1110 Gen COE Engr & Des Corres Files- '82  
Subject: Hurricane Protection Lake Pontchartrain LA &  
Vicinity Citrus Lakefront Levee- IHNC to Paris Road  
Foreshore Protection (GDM-Revision)

ENGINEERING DIVISION  
Permit Review  
Sheet

SUBJECT: EM-19-990-1624, Appl by the New Orleans Sewerage & Water Board for work in Lake Pontchartrain.

PLAN  
SCALE: 1"=4'-0"

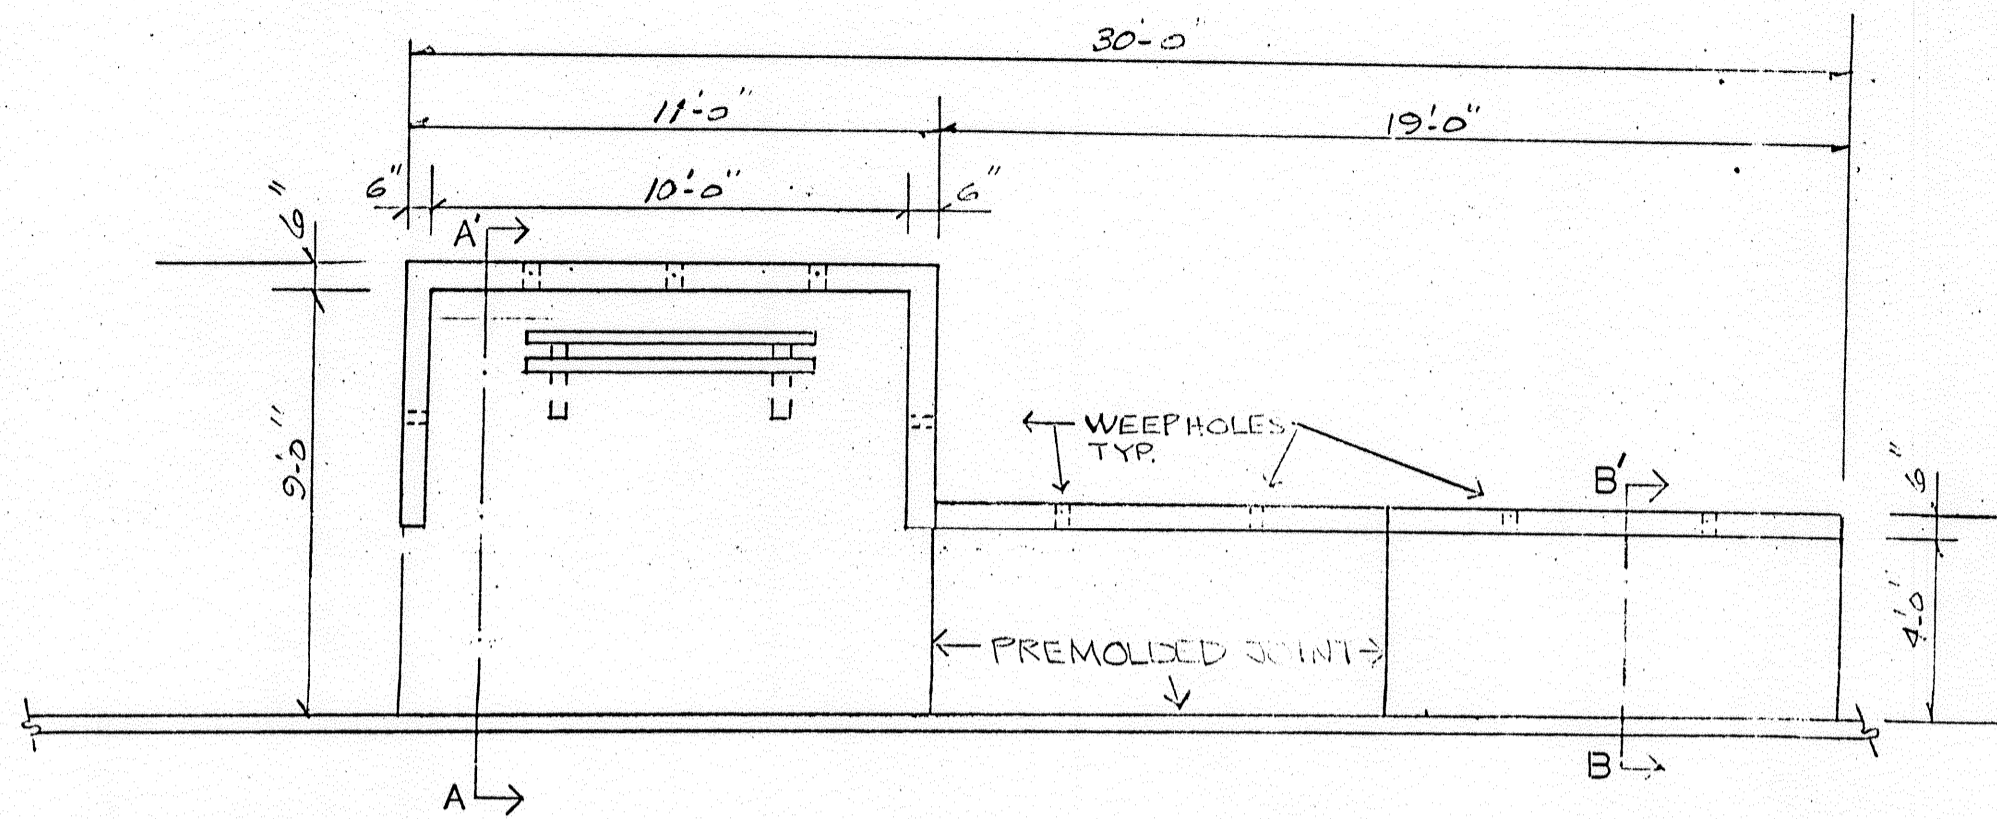
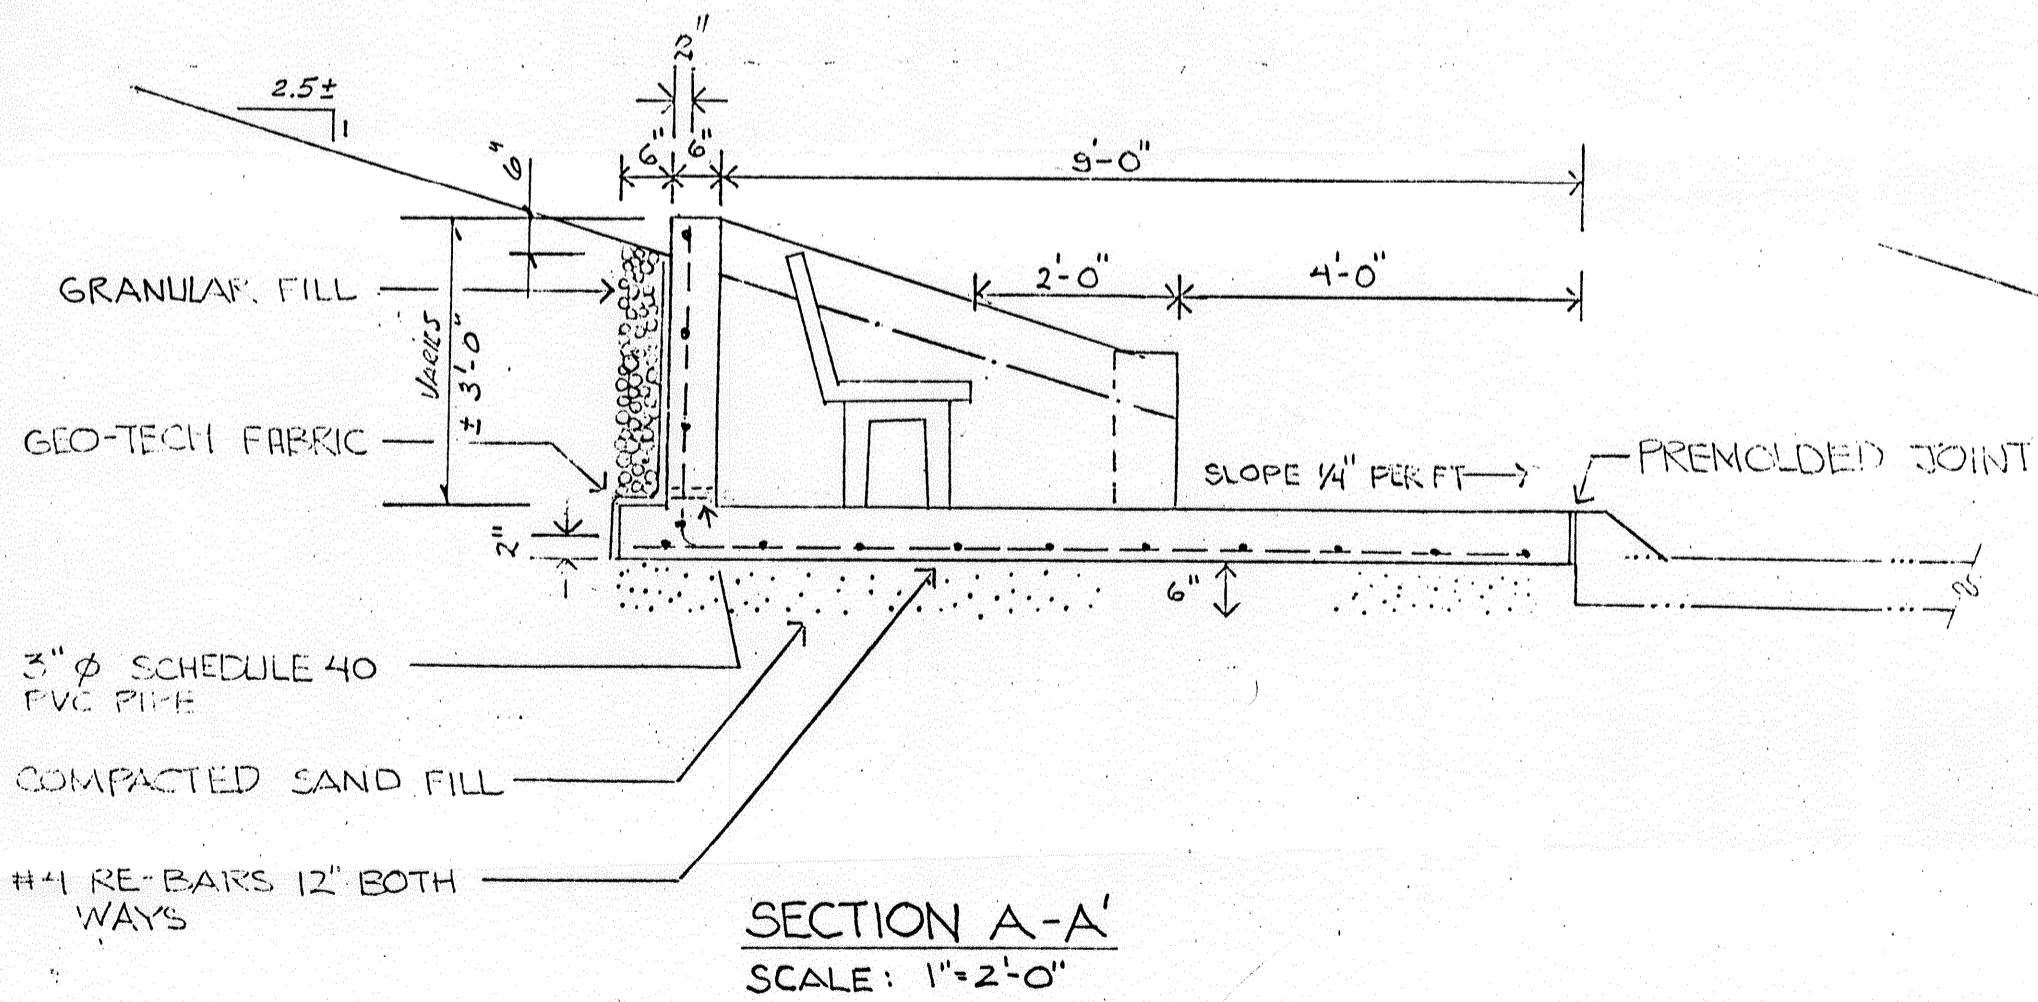
ED-FS WE HAVE NO OBJECTIONS PROVIDED AN EXCAVATION PLAN TAKING INTO CONSIDERATION THE LATERAL PRESSURES OF THE LEVEE IS DESIGNED AND FURNISHED TO THIS OFFICE FOR REVIEW.

SEWERAGE AND WATER BOARD OF NEW ORLEANS	
CONTRACT 3498	
DR. D.A.H.	GENERAL SUPERINTENDENT
TRC.	
CK.	
AP.	DWG. No. 7495-SW
SCALE	
DATE 8-8-76	SHEET NO. 45

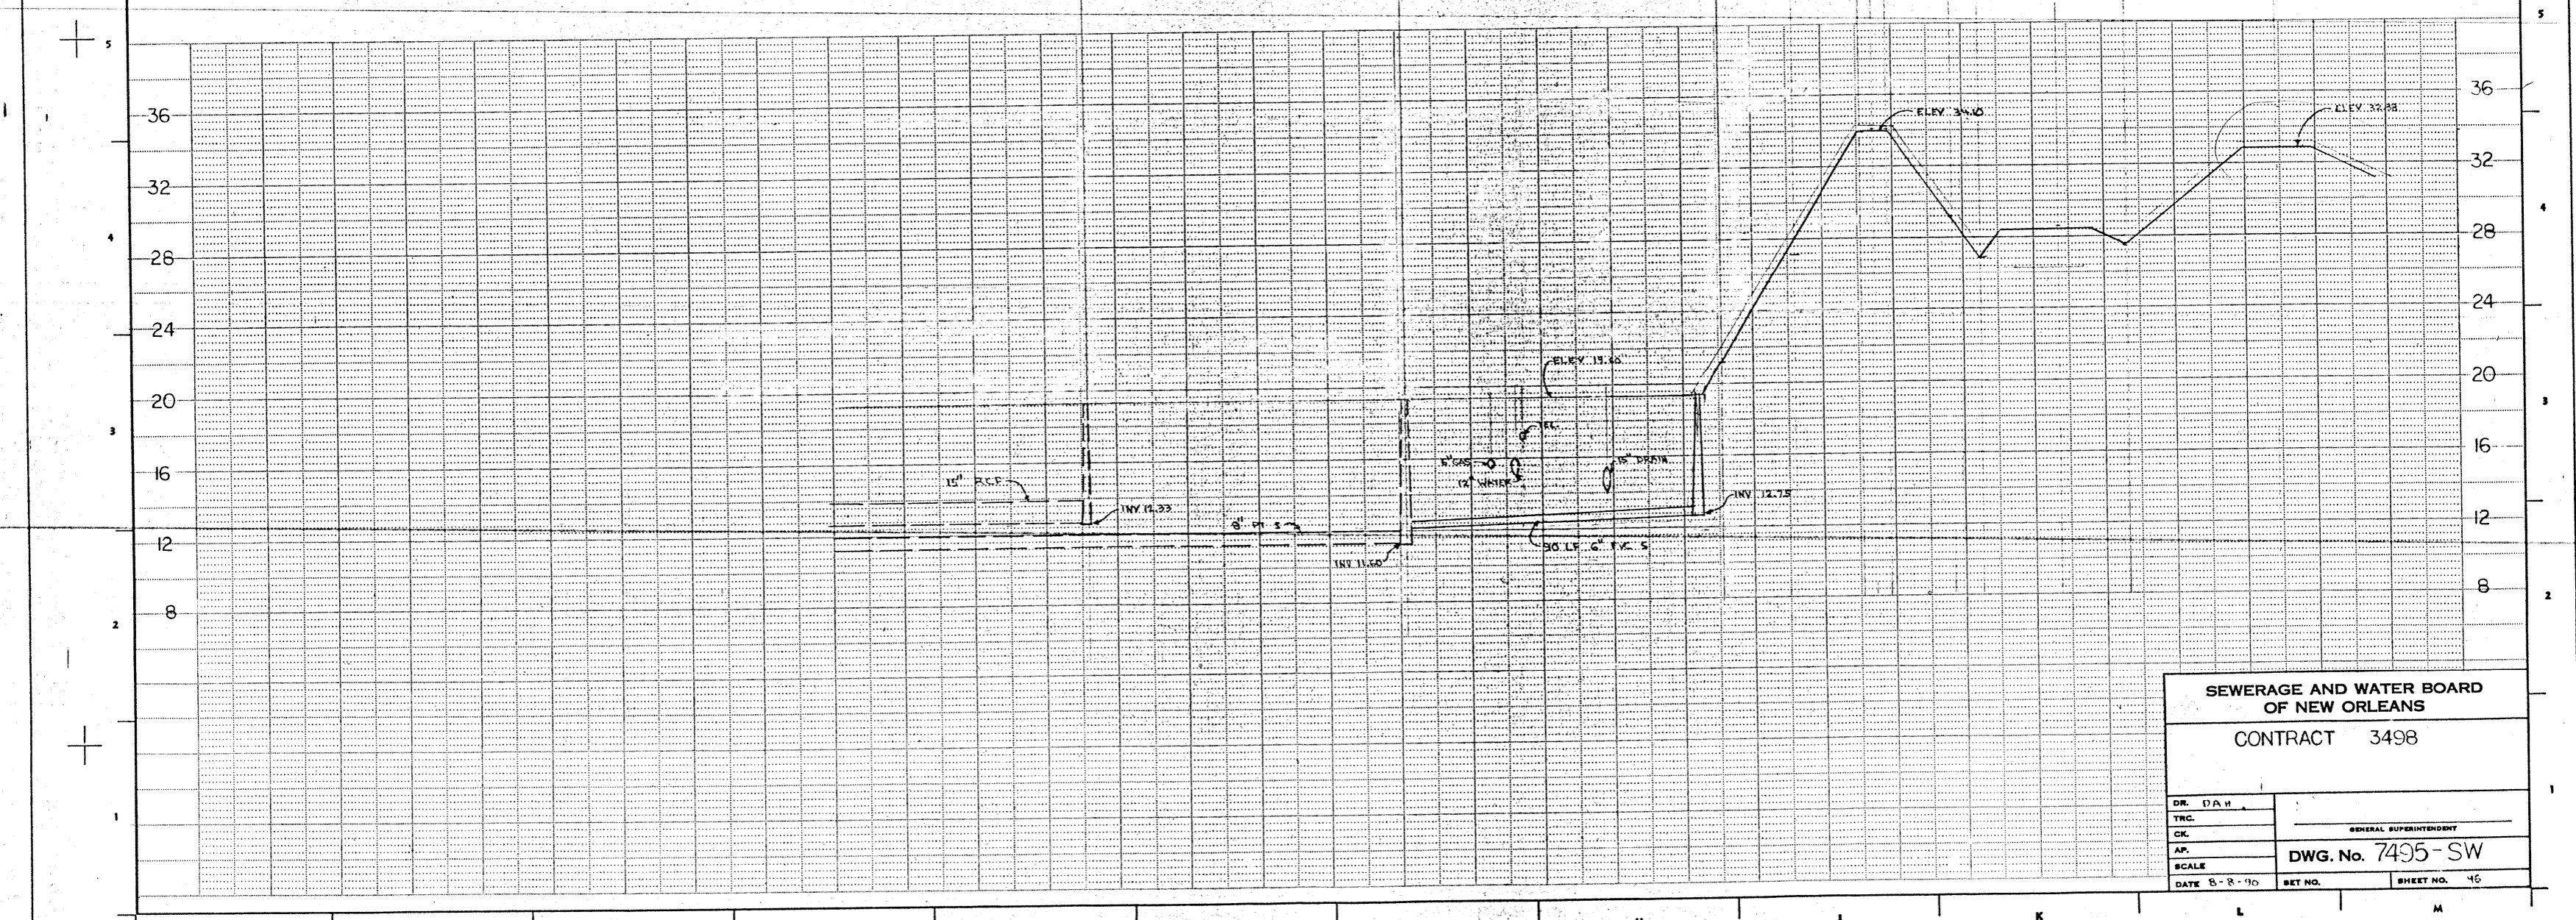
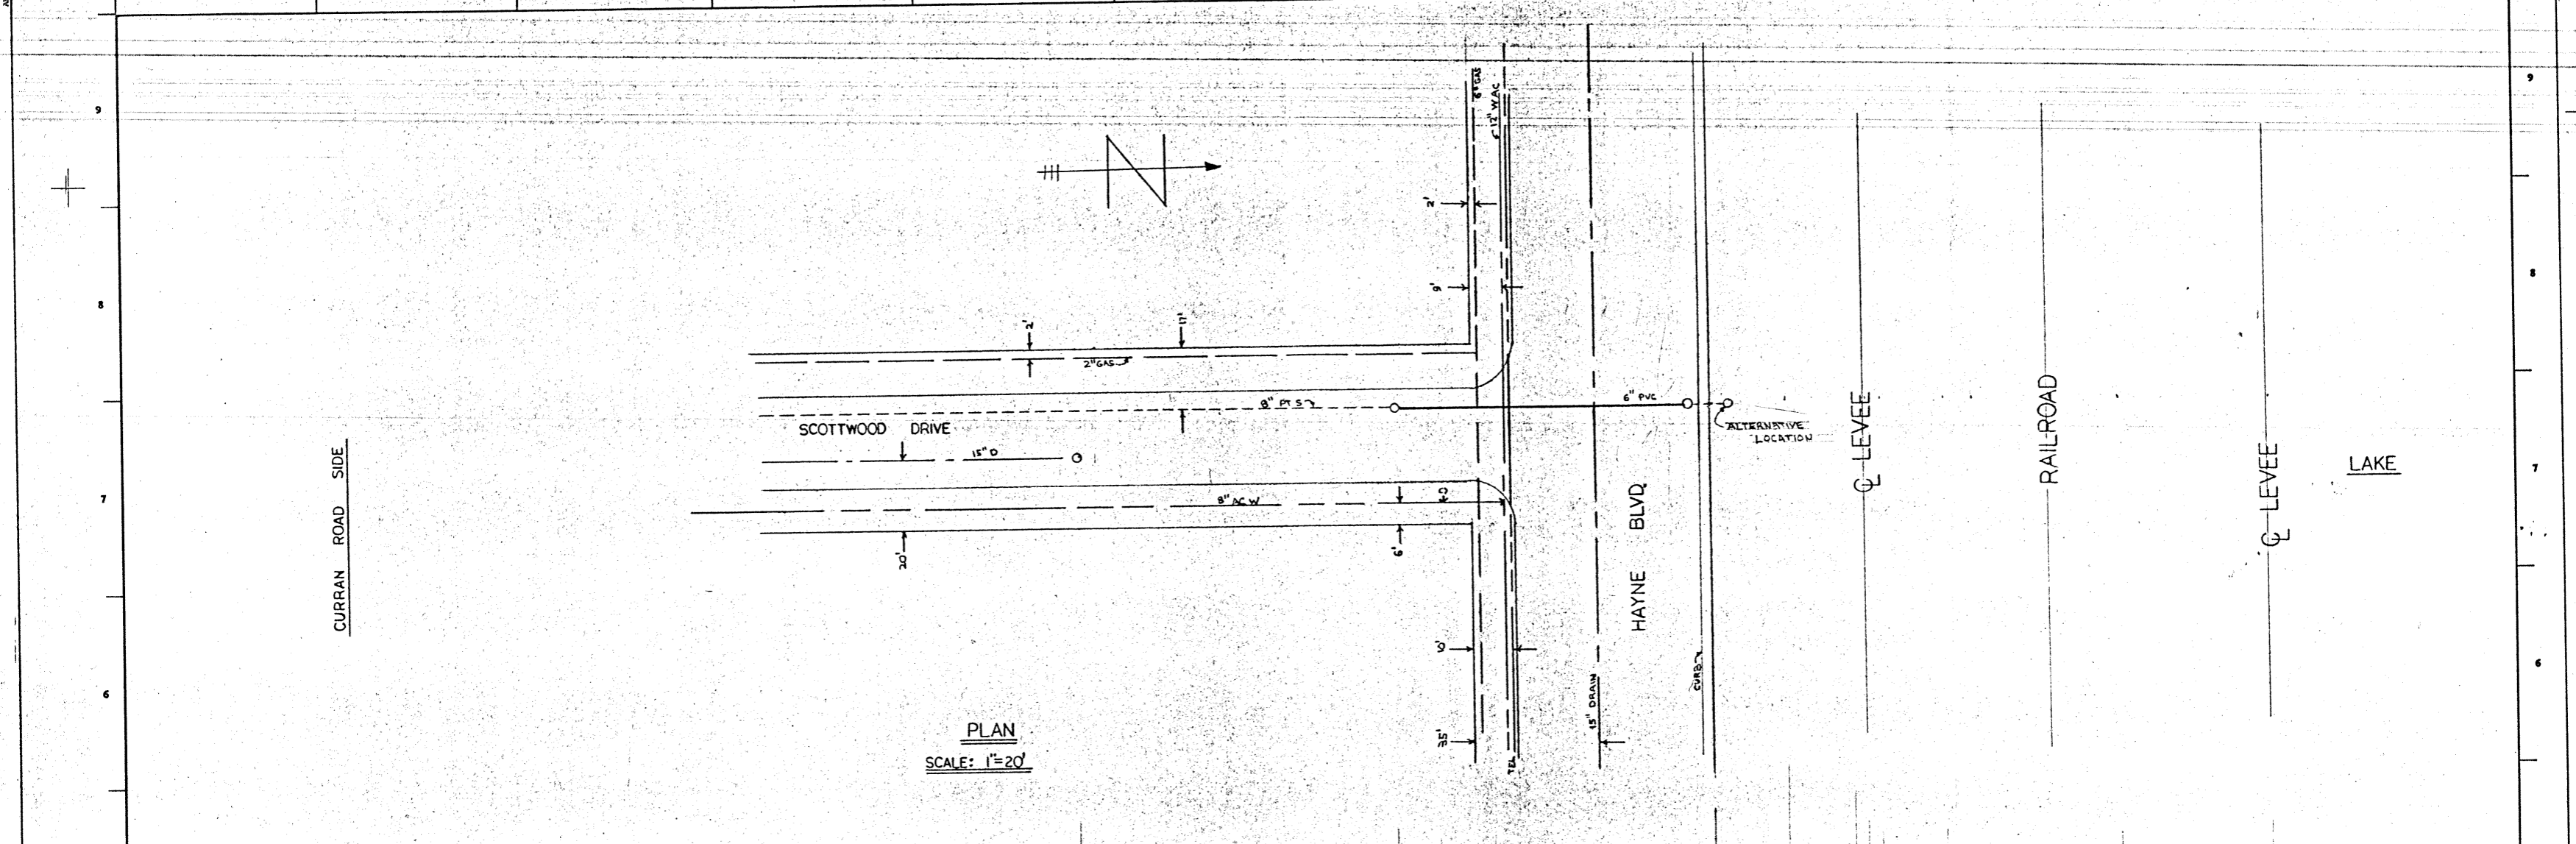
1. Due to the steepness of the existing levee slopes, we suggest that the applicant resubmit a plan for embedding the pipeline 12-inches below the side slopes and at or above the stillwater elevation<sup>of</sup> 11.5 across the levee crown.

2. The applicant should provide details for passing the pipeline through the railroad embankment. If excavation is required on the floodside levee toe, we will need to review the excavation plan for determining levee stability.

3. If the alternative location for placing the manhole on the protected side levee slope is selected, the applicant will be required to submit an excavation plan for our review and approval prior to commencing construction.

SR - No objection relative to relocation actions. Ask owner to clarify that he will place pipe and cover over the levee, as these specifics are not adequately presented on drawing. J. Gasiano
